# DEVELOPMENT REVIEW BOARD REPORT

### **Silverstone Parcel G North 9-PP-2017**

1. Request approval of the preliminary plat for a 182-lot residential subdivision, including the landscape plan, circulation plan, open space plan, and site amenity building elevations, all on approximately 23.73 acres. Dwelling units will consist of duplex and multi-unit townhouse buildings.

SILVERSTONE - PARCEL G  
 K-Hovnanian Homes PP 2.0

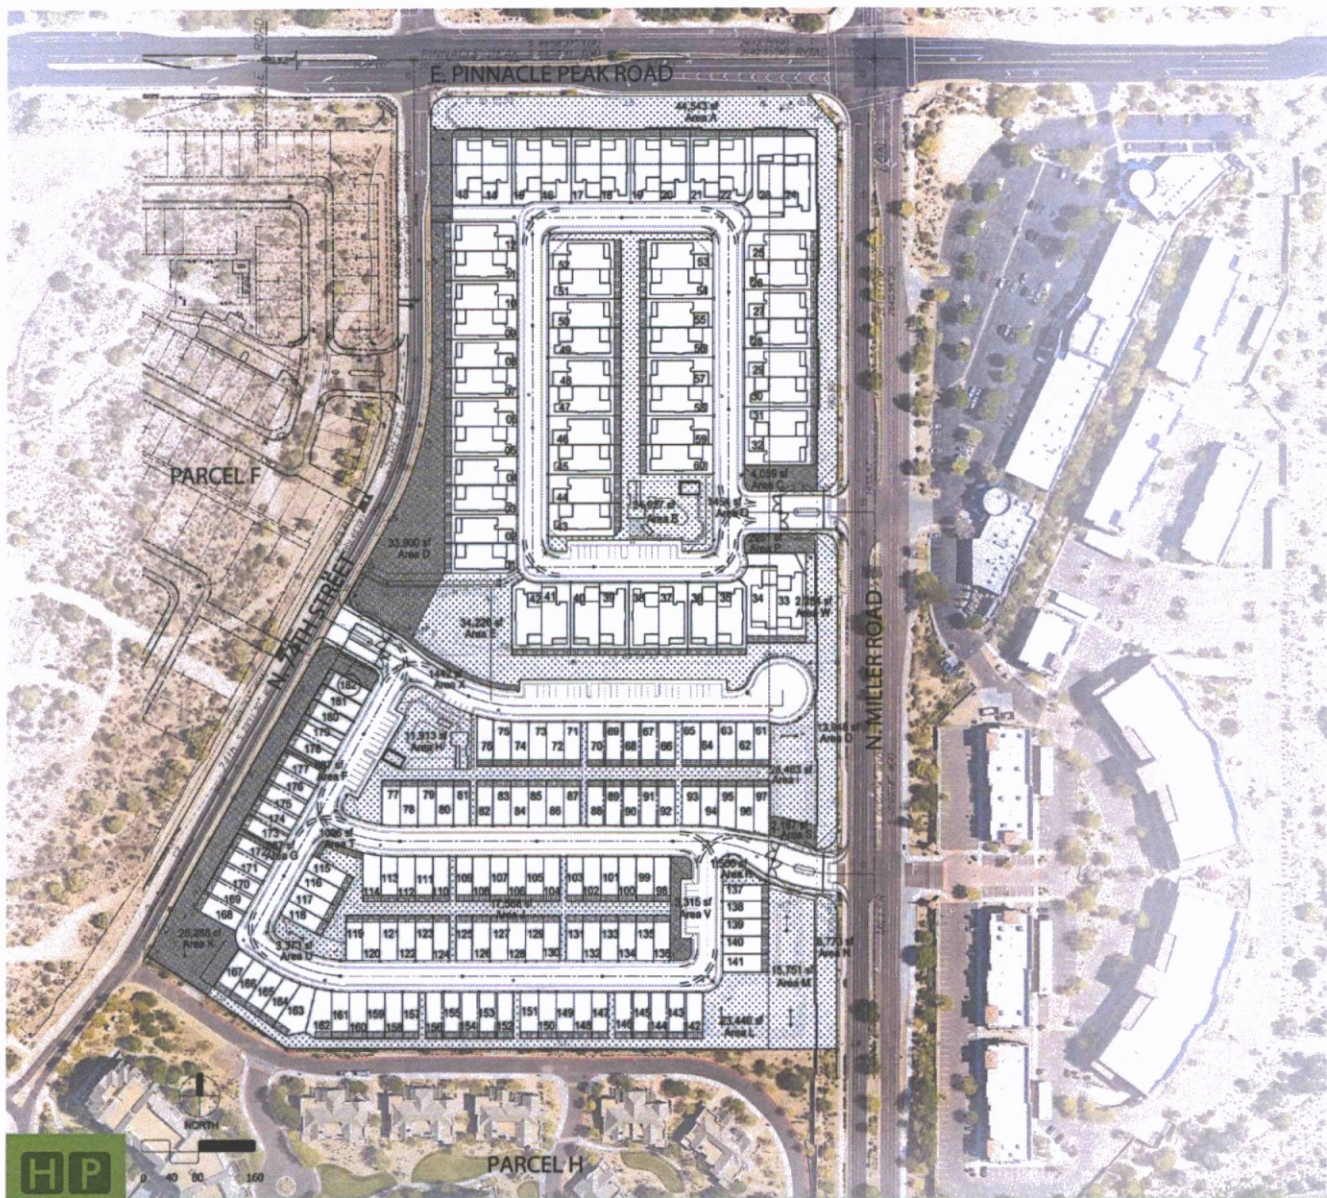
51. Please provide a black line drawing/plan of the Open Space Plan Sheet PP 2.0. Please revise the 'Open Space Plan' so that the gray-tones and cross-hatched patterns, that denote the different open space areas, will be lighter tones and less dense patterns. As shown, when these gray-tones and cross-hatched patterns are shown on 8 1/2 x 11 copies, they become too dark and blurred and difficult to read (Zoning Ordinance Section 1.303 and the Plan & Report Requirements for Development Applications).

SILVERSTONE - PARCEL G  
K-Hovnanian Homes PP 8.1

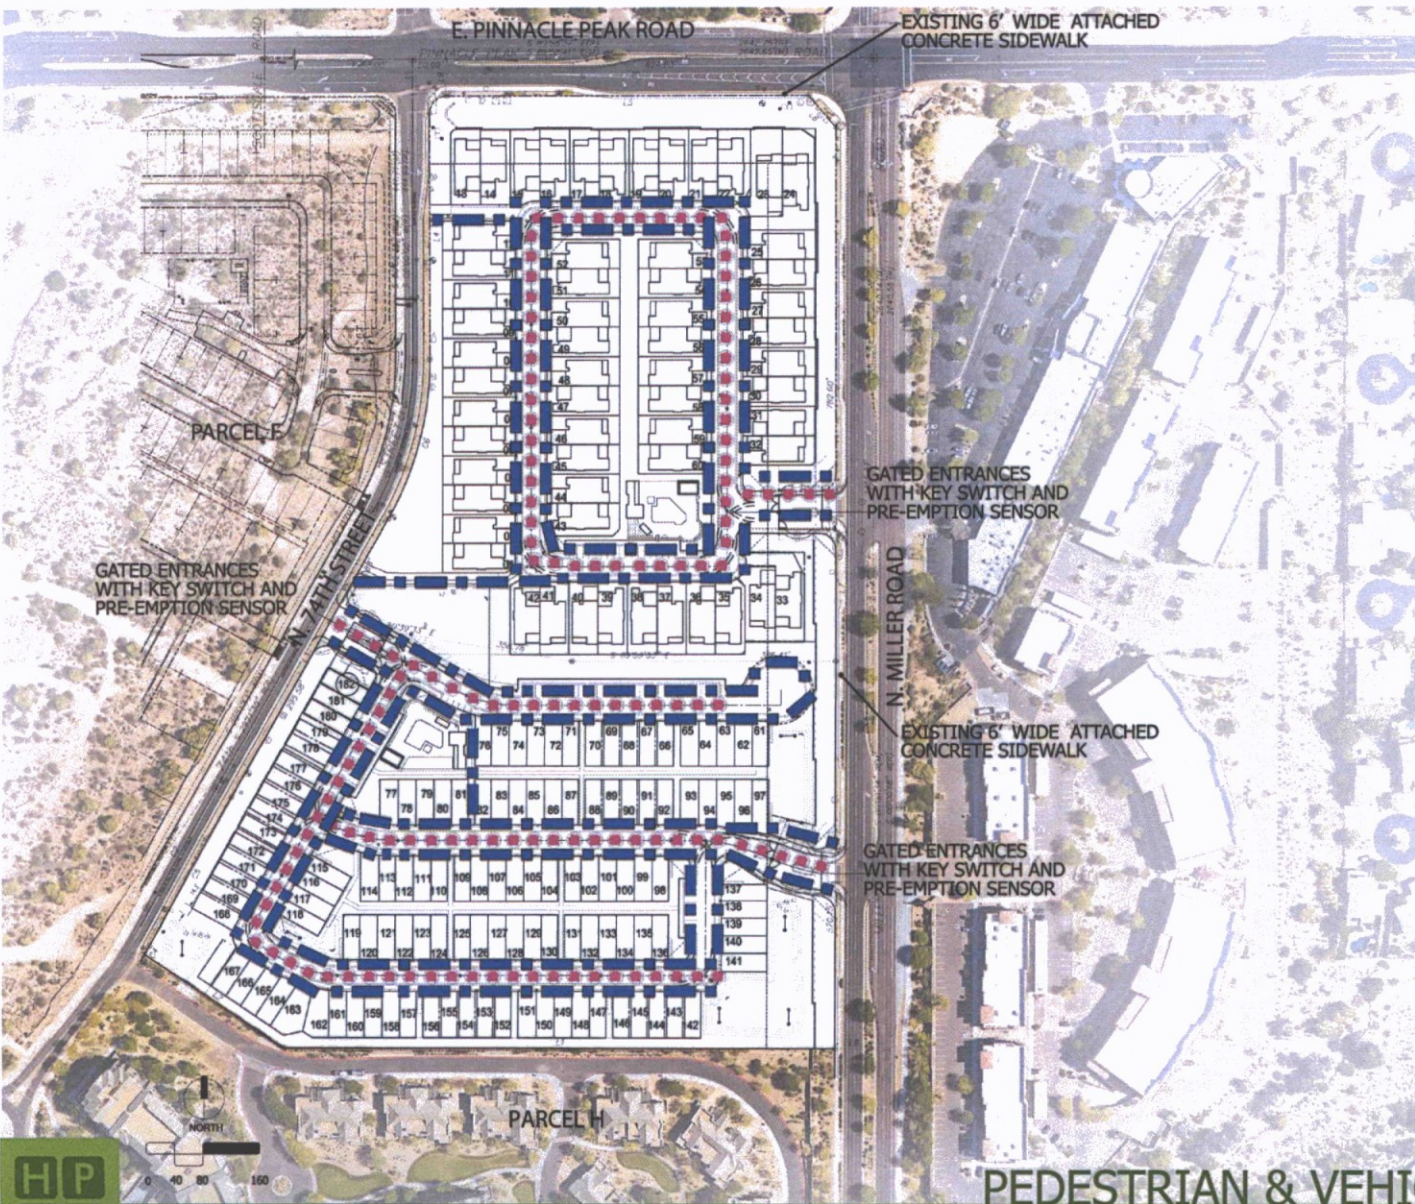
35. On Sheet PP 8.1, Enlarged Entrance Plan and Elevation, please revise the plan so that it will be consistent with the elevation, specifically regarding the pedestrian gates that are shown in elevation but not shown in plan. Please refer to the Plan & Report Requirements for Development Applications (Zoning Ordinance Section 1.303).

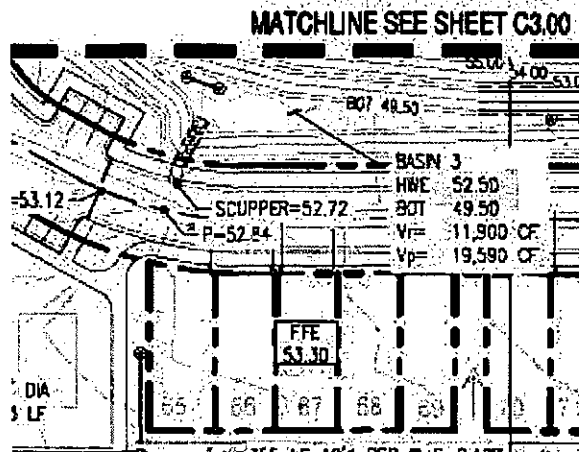
18. Please review and revise proposed FF elevations to be compliant with section 5.0 of preliminary drainage report. Some structures have less than identified 12" of freeboard from retention basin high water level.

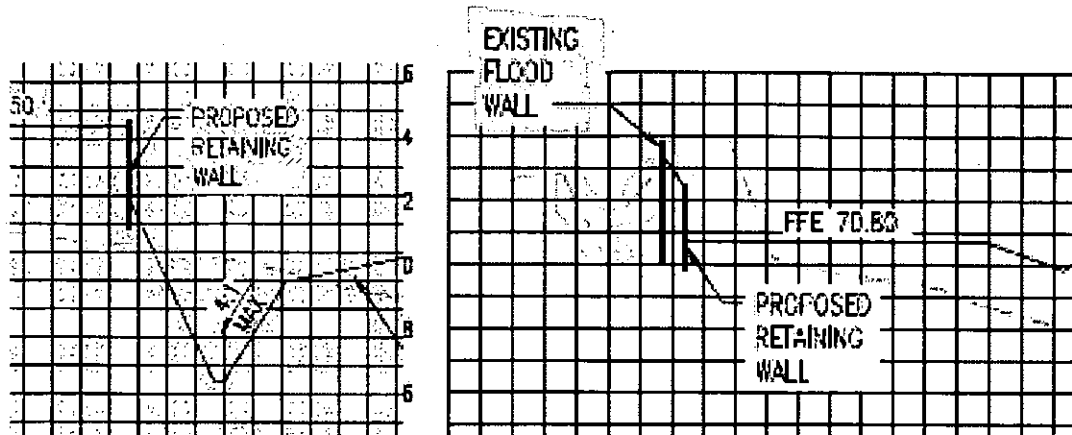
22. Depict HWL in all swales and/or adjacent washes in profile sections. Consider adequacy of existing food walls. Please provide the: flow, velocity and scour depth in highlighted wash section for the details below:
